**Planning, Land Use and Mobility Committee
Case Report /Motion Reconsideration 11.19.20
DIR-2019-4531-DRB-SPP-MSP / Single Family Residence
4314 Canoga Drive
Woodland Hills, CA 91364**

Project Description: New Single Family Residence
Applicant / Rep: Ashraf Hemmati c. 310.709.3854; e:ashrafmemar@gmail.com
LA City Planner: Valentina Knox-Jones: 818.374.5038; valentina.knox.jones@lacity.org
Case Leader: Lauren Coffman / PLUM Chair / l.coffman@whcouncil.org
PLUM Meeting: October 3, 2019 / First Presentation
July 16, 2020 / Second Presentation
August 6, 2020 / Third Presentation
November 19, 2020 / PLUM reconsideration of Motion

Site Plan

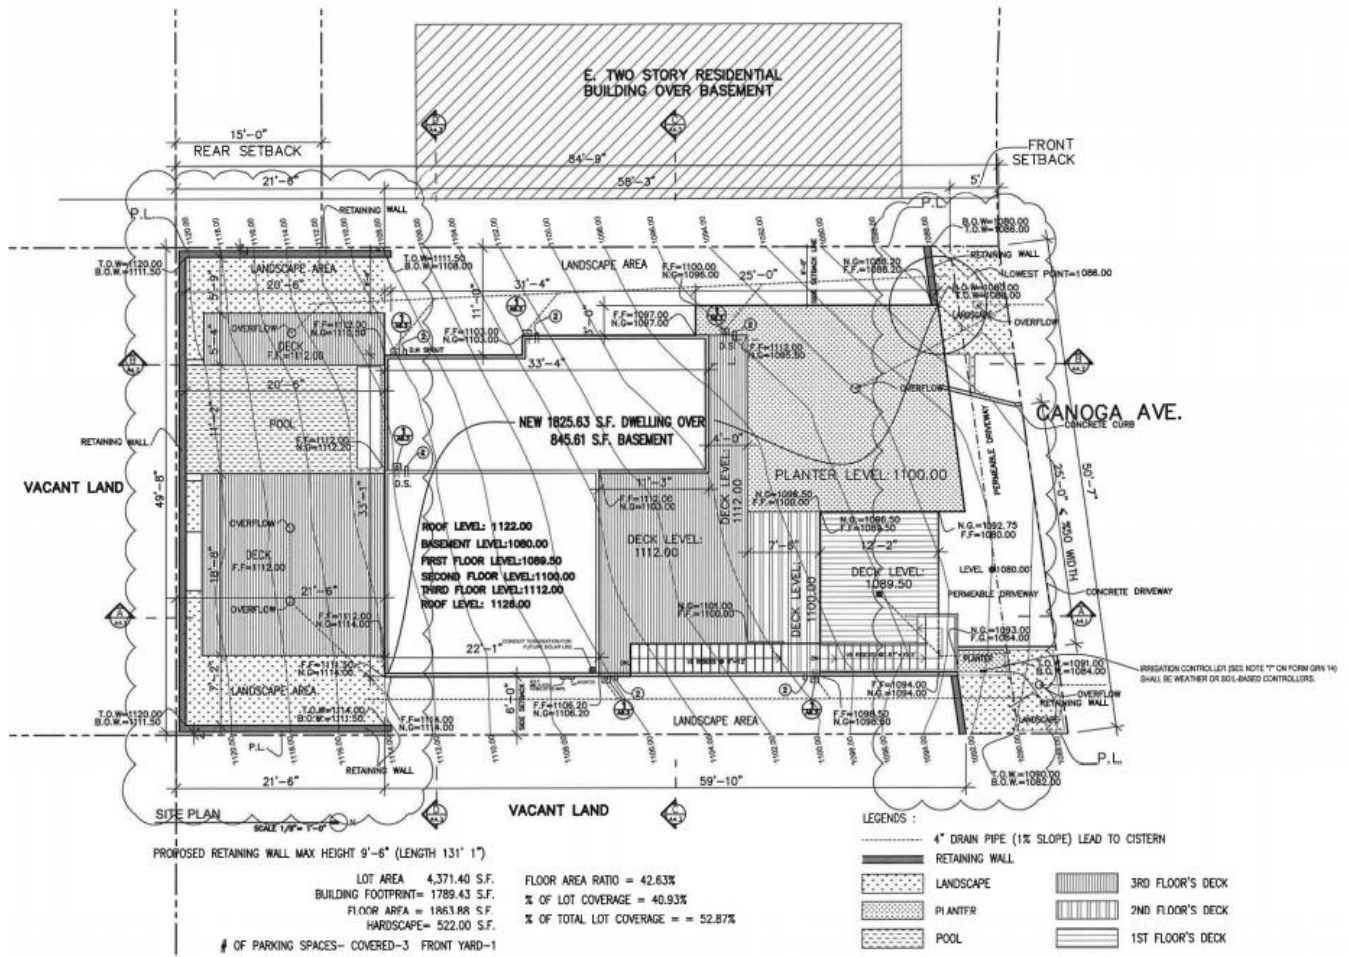
Site Drainage: Site drainage, is an issue for this site and the street, **Aside from the required planters, what is site drainage?**

Grading: The project requires 1,100.1 cubic yards of cut and 9.08 cubic yards of fill for a total export of 1,091.03 cubic yards for grading. **Maximum allowable, as per the Hillside Ordinance is 1,000 cubic yards.** **Lots fronting on Substandard lots are limited to 750 cubic yards of cumulative grading.** The project proposes to work with the average natural slope of 35%. There are no trees proposed to be cut down.

Is Canoga Drive considered a substandard street?

As per Baseline Hillside Ordinance, front yard setback is 20' but not less than 20% of property depth. for R1. The site plan shows a setback of 5'. Explain.

Sidyard setback: required is 5'. For buildings over 18' in height, "One additional foot shall be added to each required side yard for each increment of 10 feet or fraction thereof above the first 18 feet. This building is 46' high. So the sidyard setback is 8' wide, or an additional 3' added to the minimum 5' wide setback requirement.

Original Site Section

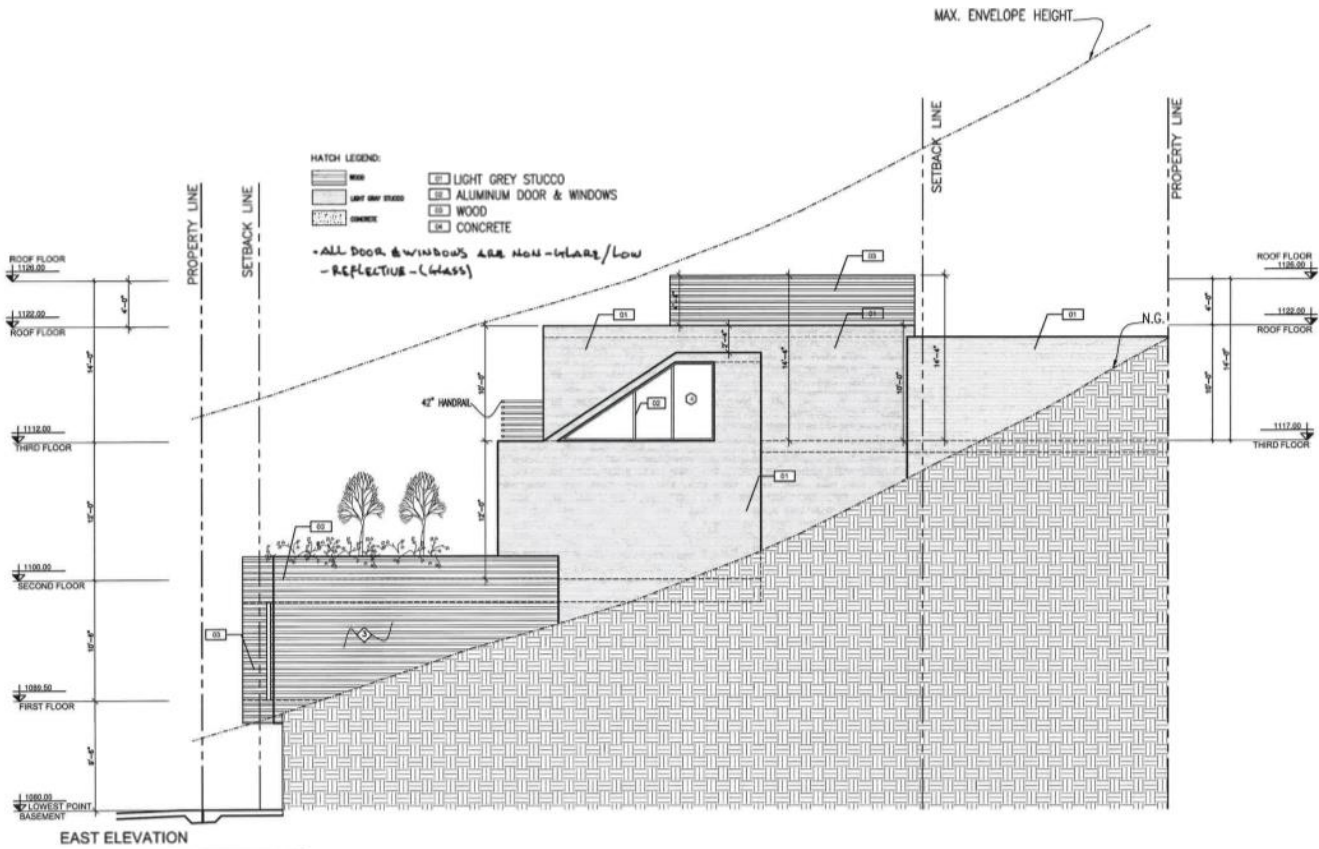
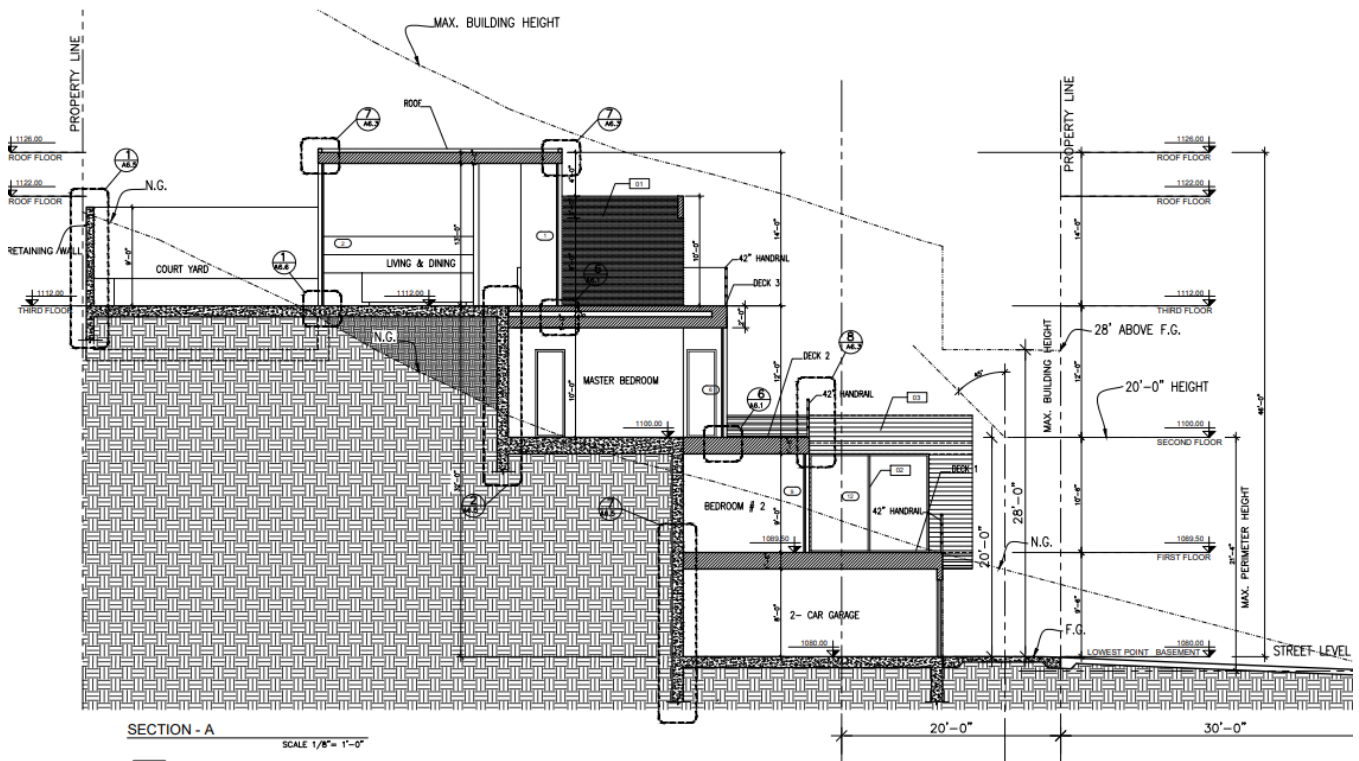
1. As per the Baseline Hillside Ordinance, the maximum envelope height for the R1-1 Zone, for a project with a roof slope less than 25% is 28 feet. This vertical height or “plumb line” height is originated at the lowest grade within 5 horizontal feet of the exterior walls of the building structure, and is the vertical distance from the grade of the site, to a projected plane at the roof structure or parapet wall located directly above and parallel to the grade.

2. The Overall Height is indicated as 50’ from finished grade to the top of the flat roof / parapet. This building appears to be taller than the allowed height of 45 feet by the *Baseline Hillside Ordinance*.

- As per the Baseline Hillside Ordinance, on a substandard hillside street, no portion of a building or structure within 20 feet of the front yard lot line shall exceed 24 feet in height. The 24 foot height shall be measured from the midpoint of the street on which it faces.

8.6.20 The projected plane needs to be 28’ from finished or natural grade, whichever is lowest. In the New Site Section, the projected plane includes a vertical cut line. This is not part of the projected plan, as it is a vertical cut in the projected plan, where the site is being cut back as needed to conform with the 30’ wide required street upgrade. As per the definition of grade in the baseline hillside ordinance, *For the purpose of measuring height on an R1, Rs, Re or RA zoned lot in the Hillside Area, pursuant to section 12.21.C.10 of this code, Hillside Area Grade shall be defined as the Elevation of the finished or natural surface of the **ground**, whichever is lower, or the finished surface of the **ground** established in conformance with a grading plan approved pursuant to a recorded tract or parcel map section.* The vertical cut of the ground should not be considered the grade. Therefore, the projected plan should be set at 28’ above the finished grade, which is the driveway.

8.6.20: The Baseline Hillside Ordinance states, as per the Zoning Administrator’s Authority (12.21 C.10.(d)2 of the LAMC) *The Zoning Administrator may allow structures which exceed the maximum envelope height requirement of table 5 – Maximum Height of Structures; However, the increase in height may not result in a*

8.6.20: As per the New Site section, which shows the street, the building seems to comply.
